SSD-10114 | CENTRAL COAST QUARTER

RESPONSE TO SUBMISSIONS

23 MARCH 2020
P7719
DRAFT
PREPARED FOR SH GOSFORD RESIDENTIAL PTY LTD

Figure 3 – Southern Tower Articulation

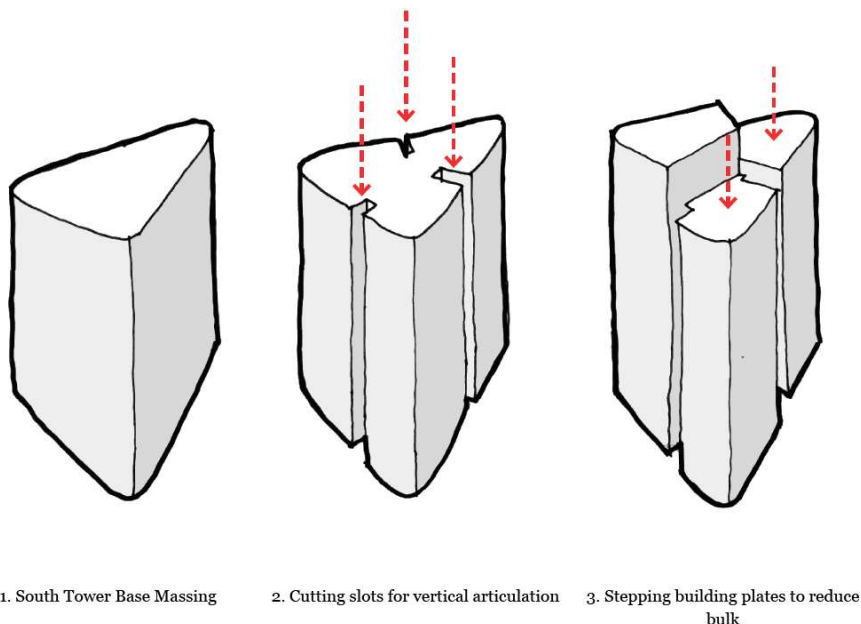
Issue	Comment	Response
7. Built Form – Southern Tower	Noting the advice from the Panel and issues raised in submissions, the Department also requests that the overall height, bulk and scale of the proposal be reviewed, and consideration given to: reducing the mass and bulk of the Southern Tower envelope, so that it presents as a more slender tower form, reduces its visual dominance from key vantage points and enhances views through the site	The southern tower has been amended to include a continual vertical break on all sides, together with a stepped roof height, making it more vertically proportioned and reducing its perceived bulk and scale. The southern corner of the tower has been brought down to street level, further accentuating the split in massing/breaking up the podium mass.

- The massing of the southern tower has been articulated through a continual vertical break on all sides. This reduces its perceived bulk and scale through it reading as two distinct forms. In addition, the tower has been stepped to create three differing roof heights – with the southern corner being the lowest, consistent with the higher-level massing principles established with the CoGDAP.

Figure 5 – Revised Mann St Interface and Through Site Link

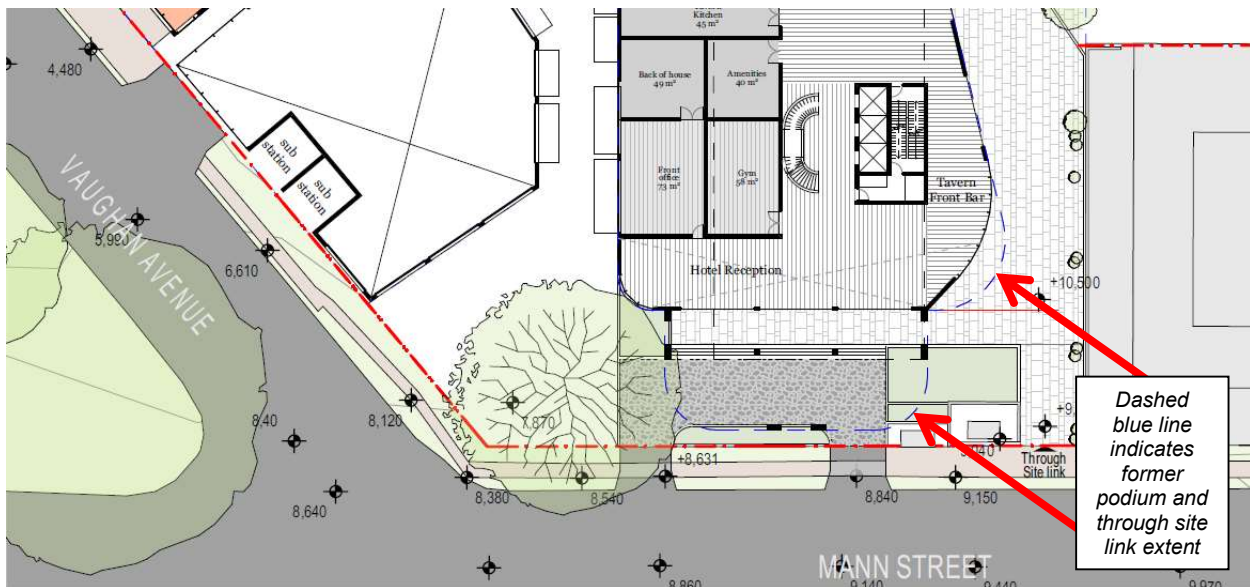
11. Built Form – Eastern Tower	relocating the Eastern Tower envelope to increase the setback from the podium street wall to respect the scale of Mann Street	The eastern tower envelope has been repositioned (setback 6m from the podium wall) to maintain an appropriate presentation to Mann Street, consistent with this comment.

12. Built Form – Through Site Link	increasing the width of the northern through site link to provide greater amenity for the site's public domain	The eastern tower podium has been amended (reduced) to create a wider through site link passage at the Mann Street entrance to the site, consistent with this comment.

- The eastern (hotel) tower envelope has been setback 6m from the podium wall. The podium footprint has also been revised to increase the width of northern through site link.

Figure 8 – DKO Shadow Drawings

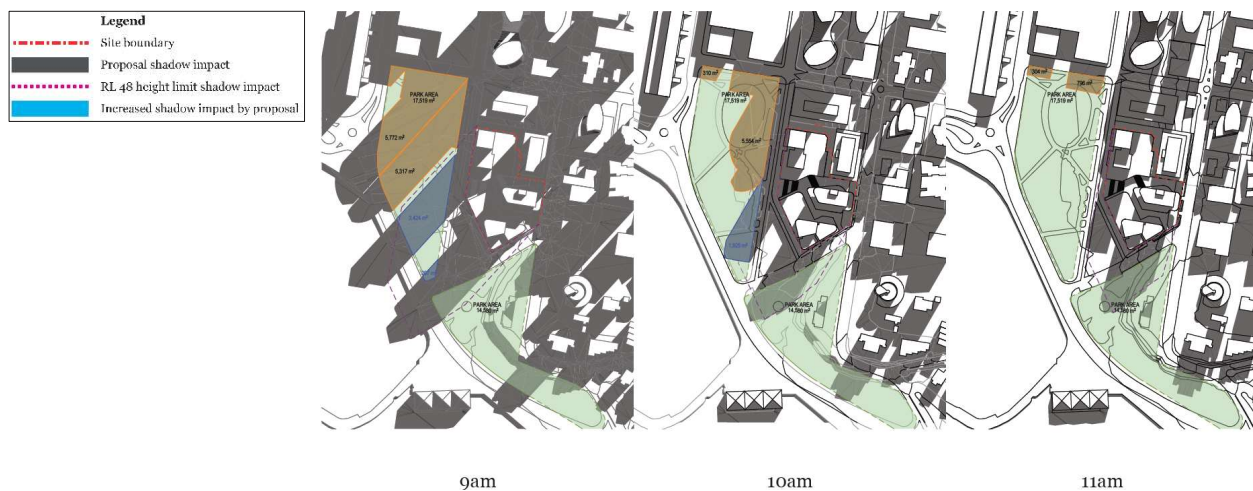
Issue	Comment	Response
19. Amended Shadow Diagrams	Noting Council's concerns about potential solar and amenity impacts associated with the proposal, the Department requests amended shadow diagrams showing the solar access impacts (for summer and winter solstice and spring and autumn equinox, at hourly intervals between 9am and 3pm) to the surrounding public domain, including Leagues Club Field, Poppy Park, the Memorial Park and the Waterfront and likely solar access to the proposed through site links.	DKO has prepared updated solar drawings in satisfaction of this comment. The drawings demonstrate that the proposal complies with the SEPP and DCP controls pertaining to shadowing. In relation to Poppy Park, it is noted that the primary gathering space is currently shaded by dense tree plantings, which are retained on the Council's local heritage register. The trees (that shadow the park) are unlikely to be removed in the short to medium term. The shadow impact of the proposal above/beyond the existing condition is therefore considered negligible and inconsequential (notwithstanding its compliance with the DCP controls).

- 100% of Leagues Club Field receives 4 hours of direct sunlight; and
- Poppy Park is only affected by the proposed (height and FSR) variations between 10am and 11am. It is also noted that these spaces are significantly overshadowed by existing (heritage-protected) vegetation.

Figure 12 – View from Rumbalara Reserve

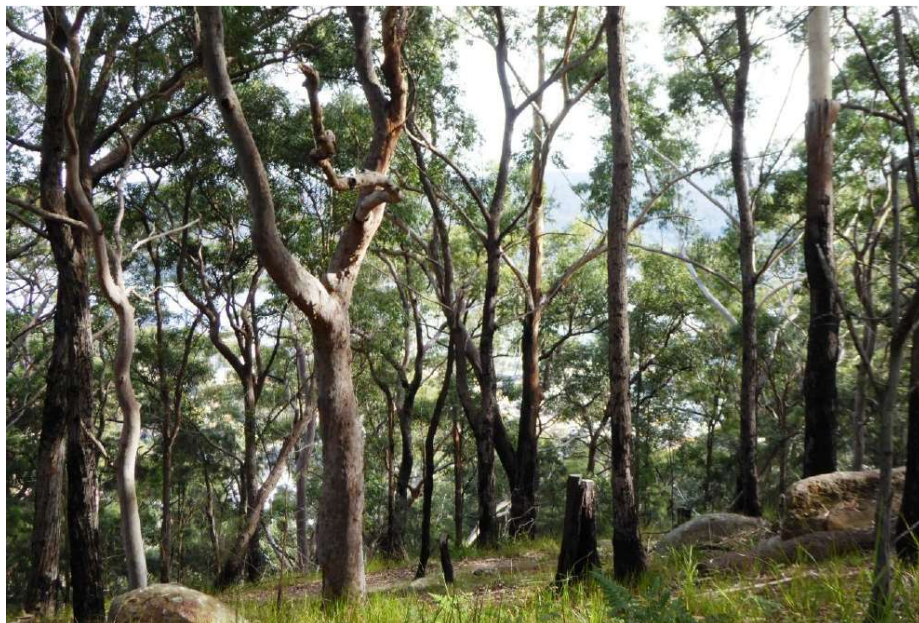
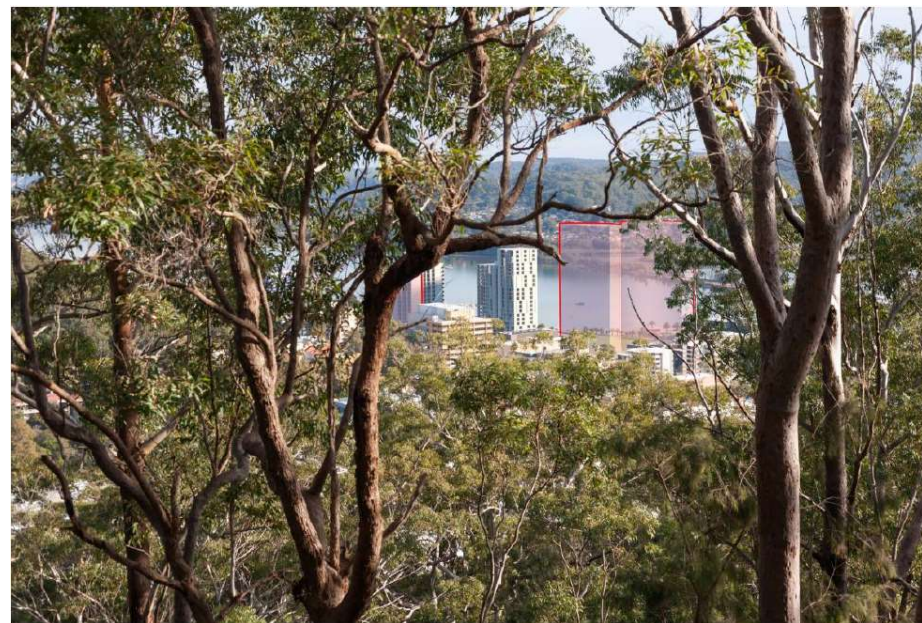
Issue	Comment	Response
	of public spaces resulting from non-complying height and FSR is unacceptable. Though the proposal is supported in principle, it is considered to have detrimental impacts on Leagues Club Park and views of Rumbalara Reserve and must be amended to address these issues.

- While the extensive tree cover across the Reserve creates an attractive natural landscape experience for visitors, it also screens most views towards Gosford and Brisbane Water as shown in Picture 9. Gaps in the tree canopy do provide some glimpses that are framed by tree trunks and canopies.
